November 3, 2009

Subject: Request for Authorization for the Model NAC-LWT Cask with Impact Limiters Containing an Alternate Attachment Gusset Tab Configuration.

Docket No. 71-9225

Figure 2.6.7-15 Impact Limiter Lug Detail

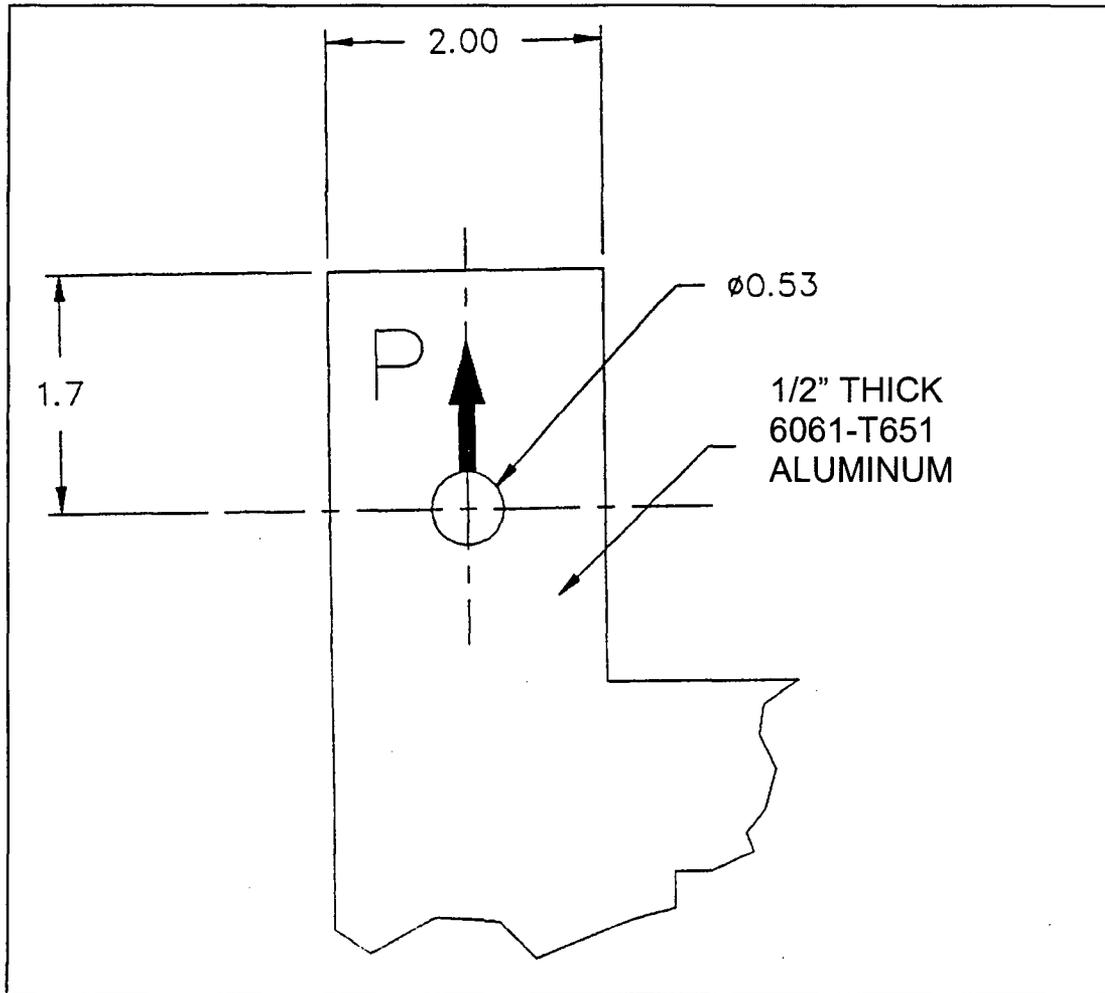
- Page 2.6.7-76, Figure 2.6.7-15 – changed “6061-T6 Aluminum” to “6061-T651 Aluminum.”
